SUBDIVISION AUTHORITY MINUTES

MEETING NO. 36

RE: Tentative plan of subdivision to create 203 single detached residential lots, 106 semi-detached residential lots, 56 row house residential lots, two (2) multiple family lots, two (2) Municipal Reserve lots, and three (3) Public Utility lots from NE 31-51-23-4, Lot 1, Block C, Plan 082 0895 and Lot A, Plan 5736RS located west of 17 Street NW and south of 23 Avenue NW; **LAUREL**

RE: Tentative plan of subdivision to create 45 single detached residential lot, 58 semi-detached residential lots and one (1) Public Utility lot from SW 3-54-24-4, located east of 82 Street and north of 170A Avenue; **SCHONSEE**

SUBDIVISION CONDITIONS OF APPROVAL MAP

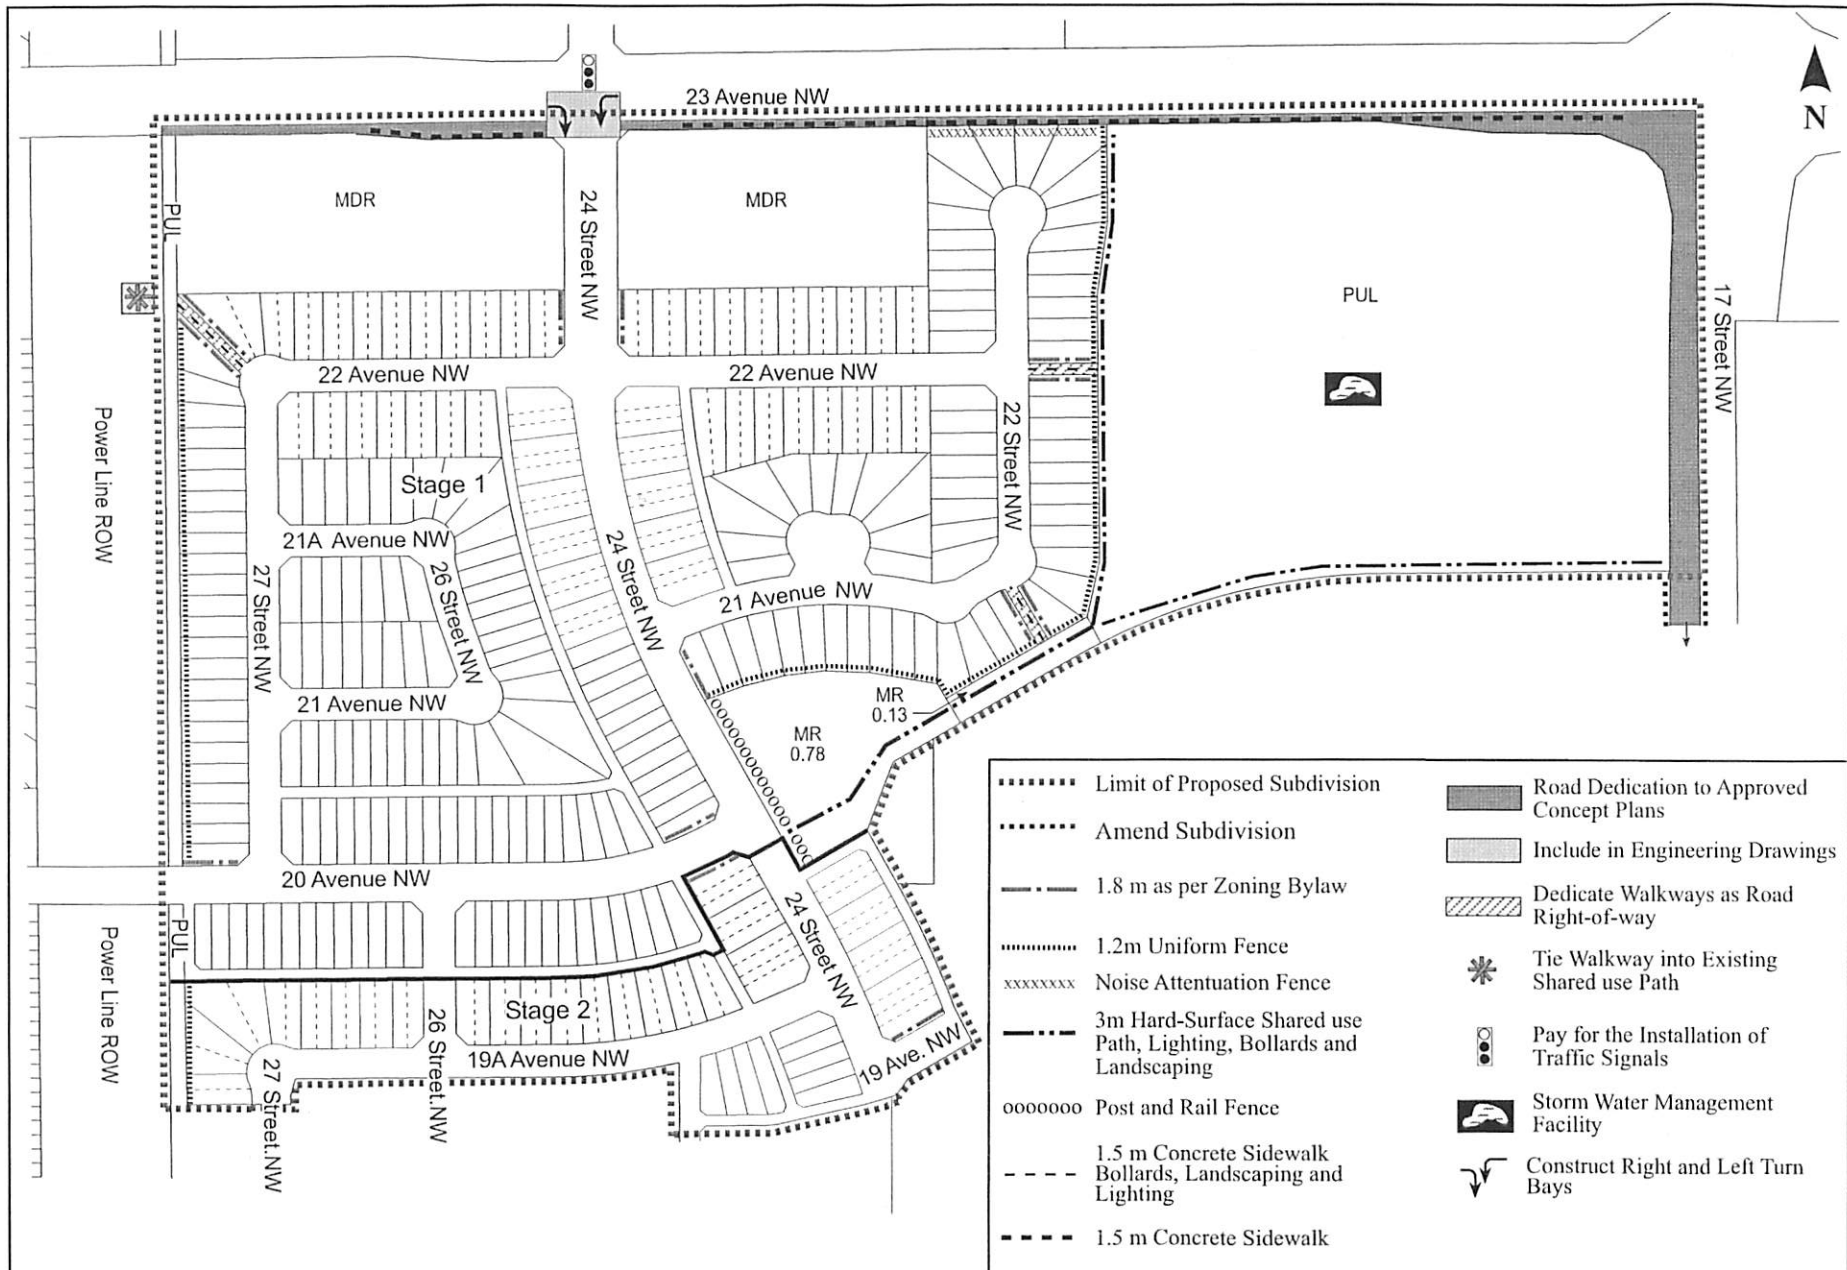
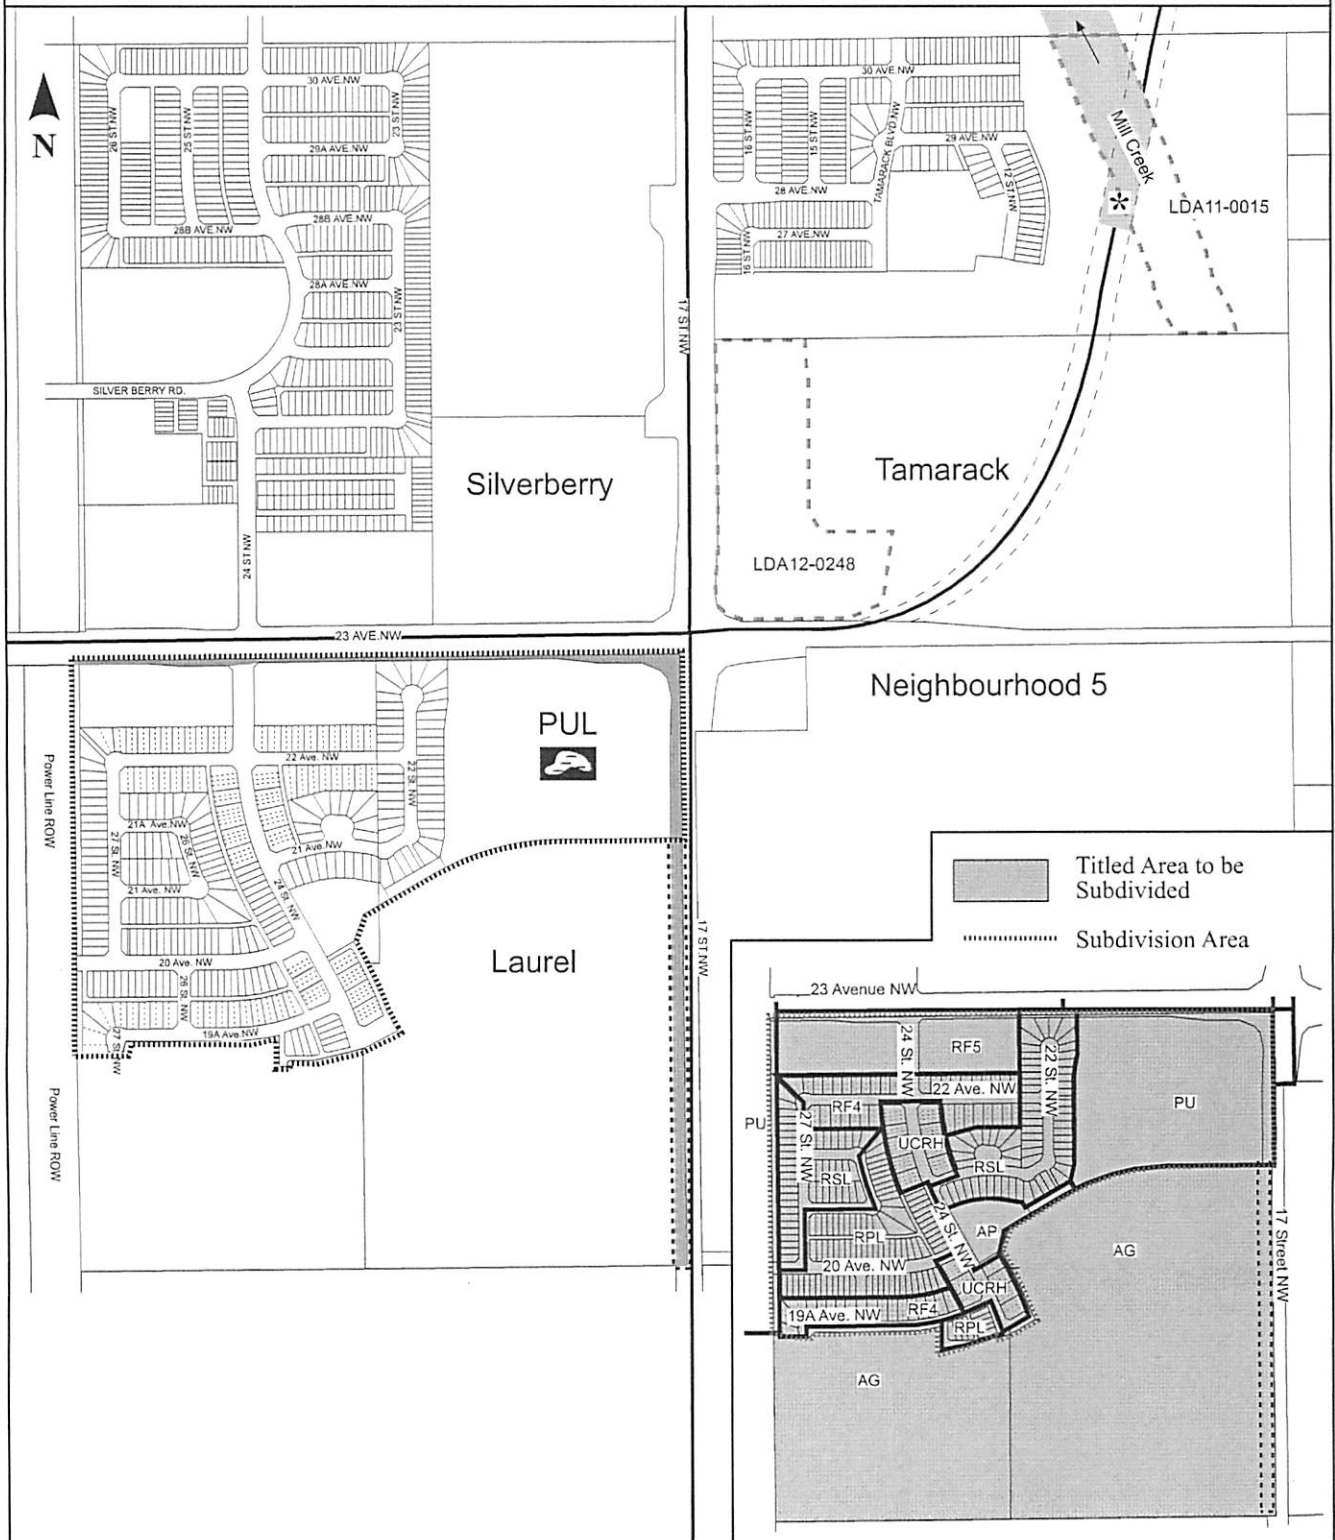
1. that the owner dedicate Municipal Reserve as a 0.78 ha parcel and a 0.13 ha parcel pursuant to Section 666 of the Municipal Government Act as shown on the "Conditions of Approval" map, Enclosure I;

5. that the owner dedicate road right-of-way to conform to an approved Concept Plan or to the satisfaction of Transportation Services for 23 Avenue NW, as shown on the "Conditions of Approval" map, Enclosures I and II;

6. that the subdivision boundary be amended to include the dedication of the 17 Street road right-of-way to conform to an approved Concept Plan, to the satisfaction of Transportation Services, as shown on the "Conditions of Approval" map, Enclosures I and II;

7. that the owner be permitted to register this plan of subdivision in stages, as shown on the "Conditions of Approval" map, Enclosure I, at the discretion of the Chief Subdivision Officer, having regard to the provision of roadways and the logical extension of services;

8. that the owner provide all walkways as road right-of-way as shown on the "Conditions of Approval" map, Enclosure I; and
9. that the owner pay all outstanding property taxes prior to the endorsement of the plan of subdivision.

8. that the engineering drawings include the details of the proposed operation and maintenance for the temporary stormwater servicing, and the owner pays for the temporary pumping of stormwater from the existing terminal storm manhole 1299 into Mill Creek until permanent stormwater servicing is in place, to the satisfaction of Sustainable Development and Financial Services and Utilities, as shown on the "Conditions of Approval" map, Enclosure II;

9. that the owner completes the design and construction of the ultimate stormwater management facility, and that the CCC will not be issued until the future permanent outfall and deepening of Mill Creek is completed, to the satisfaction of Financial Services and Utilities as shown on the "Conditions of Approval" map, Enclosures I and II;

11. that the engineering drawings include the right and left turn bays on 23 Avenue for 24 Street NW, to the satisfaction of Transportation Services as shown on the "Conditions of Approval" map, Enclosure I;

12. that the owner pay for the installation of traffic signals at the intersection of 23 Avenue and 24 Street, as shown on the "Conditions of Approval" map, Enclosure I. The City of Edmonton shall complete the signal design, and the City's Electrical Services Contractor must install the signal as per the agreement between the City of Edmonton and the Electrical Services Contractor. If the timing of the traffic signals are not deemed warranted by Transportation Services within 5 years of the signing of the Servicing Agreement, the owner will be required to provide payment to the City of Edmonton for the installation of traffic signals at that time to fulfill this obligation;

13. that the owner construct a 3.0 m hard-surface shared use path with a dividing yellow centerline and "Shared Use" signage, lighting, bollards and landscaping, to the satisfaction of Sustainable Development and Transportation Services, as shown on the "Conditions of Approval" map, Enclosure I;

14. that the owner construct additional features, including but not limited to, park furniture (e.g. benches, garbage receptacles), trees and shrub beds, and directional and interpretive signage, within the 0.13 ha MR parcel, in accordance with the Laurel NSP, to the satisfaction of Sustainable Development, as shown on the "Conditions of Approval" map, Enclosure I;

15. that the owner construct 1.5m concrete sidewalks with bollards, lighting and landscaping, to the satisfaction of Transportation Services, in the locations as shown on the "Conditions of Approval" map, Enclosure I;

16. that the engineering drawings include tying the walkway connection to the Shared Use Path, to the satisfaction of Transportation Services, as shown on the "Conditions of Approval" map, Enclosure I;

17. that the owner construct 1.5m concrete sidewalks along the south side of 23 Avenue from the existing bus stop to 17 Street NW, in the locations as shown on the "Conditions of Approval" map, Enclosure I.

18. that the owner construct a noise attenuation fence as per the City of Edmonton Roadway Design Standards Drawing #5205, to the satisfaction of Transportation Services, in the location as shown on the "Conditions of Approval" map, Enclosure I;

19. that the owner construct all fences positioned wholly on privately-owned lands, and the post and rail fence on the MR parcel, to the satisfaction of the Sustainable Development, Transportation Services and Financial Services and Utilities in the locations as shown on the "Conditions of Approval" map, Enclosure I; and

SUBDIVISION CONDITIONS OF APPROVAL MAP

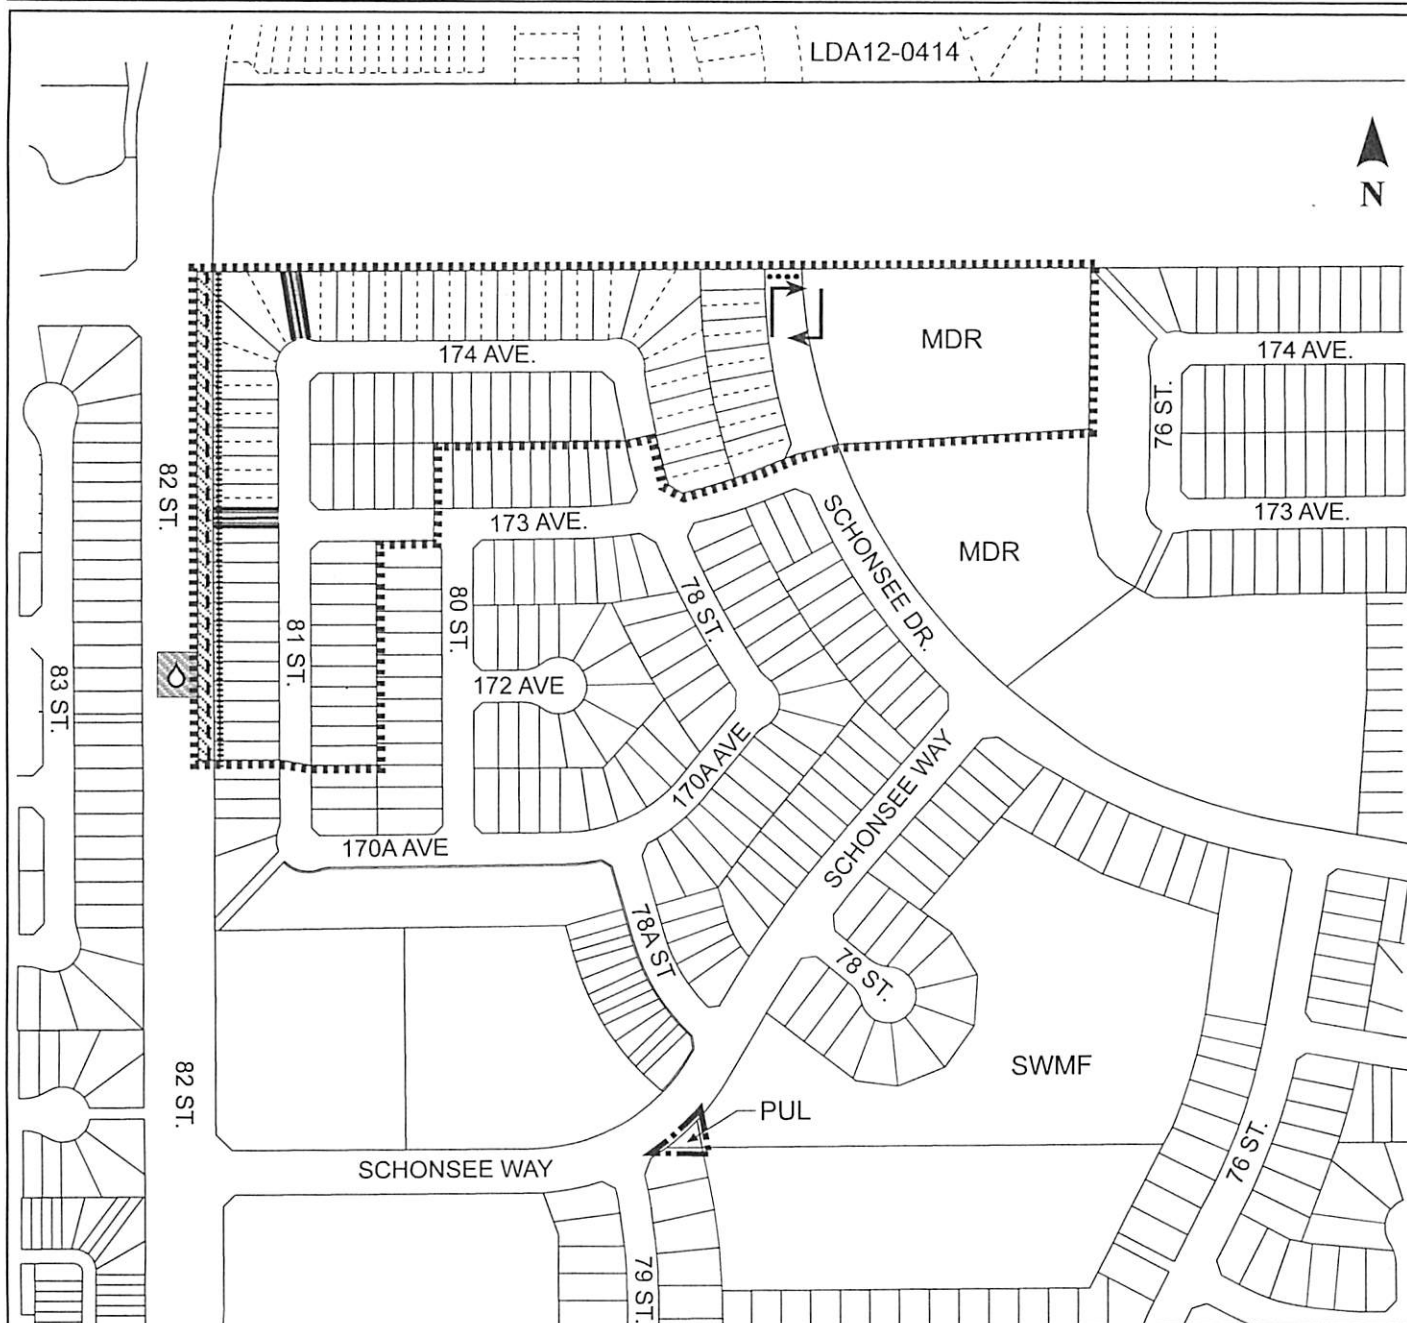
3. that the owner dedicate road right-of-way to conform to an approved Concept Plan, or to the satisfaction of Transportation Services, for 82 Street as shown on the "Conditions of Approval" map, Enclosure I;

4. that the proposed Public Utility lots located in the north and west portion of the proposed subdivision be registered as road right-of-way, as shown on the "Conditions of Approval" map, Enclosure I;

5. that the subdivision boundary be amended to include the dedication of the Public Utility lot adjacent to the stormwater management facility, as shown on the "Conditions of Approval" map, Enclosure I; and

7. that the engineering drawings include the abandonment of the existing 25 mm water service on 82 Street to the satisfaction of EPCOR Water, as shown on the "Conditions of Approval" map, Enclosure I;

8. that the owner construct a 2.5 m shared use path within the 82 Street right-of-way, in the ultimate grade and alignment including "Shared Use" signage, to tie into the existing shared use path located north and south of the subdivision to the satisfaction of Transportation Services, as shown on the "Conditions of Approval" map, Enclosure I;

9. that the owner construct an offset 17 m radius asphalt temporary transit turnaround with bollards, as shown on the "Conditions of Approval" map, Enclosure I. The turnaround will be required at FAC for roads or earlier at the discretion and direction of Transportation Services;

10. that the owner construct 1.5 m concrete sidewalks with bollards, and lighting, as shown on the "Conditions of Approval" map, Enclosure I;
11. that the owner construct a noise attenuation fence as per the City of Edmonton Roadway Design Standards Drawing #5205, within residential property lines, as shown on the "Conditions of Approval" map, Enclosure I;

12. that the owner construct all fences positioned wholly on privately-owned lands to the satisfaction of Sustainable Development in the location as shown on the "Conditions of Approval" map, Enclosure I; and
